***And in the* 78 Applications to Take and Use Water in
matter of the Valetta (55) and Ashburton River (23)
Groundwater Allocation Zones.**

Section 42A Officer's Report

STATEMENT OF EVIDENCE OF JON WILLIAMSON

4.1 I have been commissioned by Environment Canterbury to review the AquaLinc Groundwater Model of the Canterbury Plains as applied to the Valetta-Ashburton Groundwater Management Zones.

Figure 1. Typical publicised hydraulic conductivity values (after Freeze and Cherry (1979)).

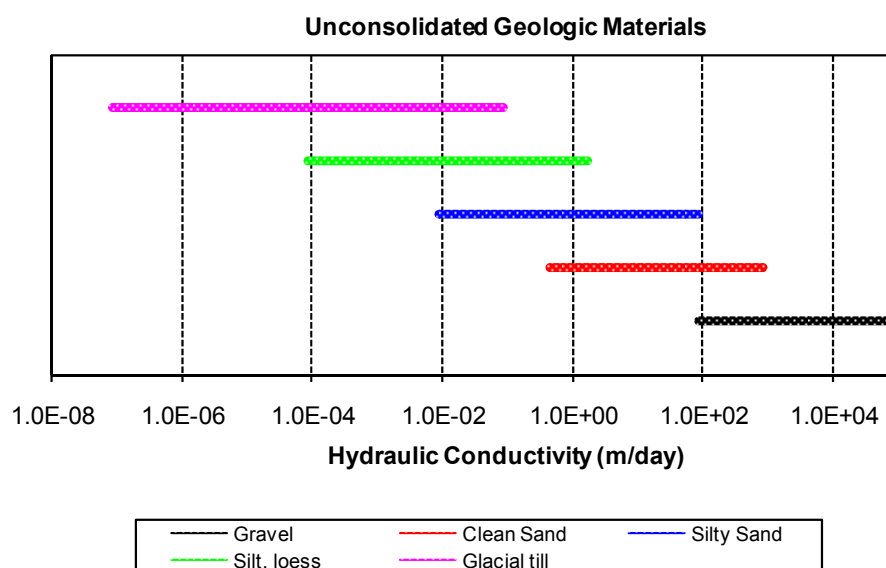
9.2 Typical published hydraulic conductivity values for a range of unconsolidated geological materials including gravels and sands are provided in **Figure 1**.

9.3 The AquaLinc (2007) model uses horizontal hydraulic conductivity (Kx and Ky) values for Aquifers 1 to 5 (see **Table 4**) that conform to the range normally expected for silty sand (at the lower end), to moderately clean gravels (at the upper end of the range). However, appraisal of the aquifer hydraulic conductivity zone figures provided in **Appendix J** of AquaLinc (2007) indicates that the distribution is more weighted towards the higher end of the range, which would seem appropriate based on the information available to me.
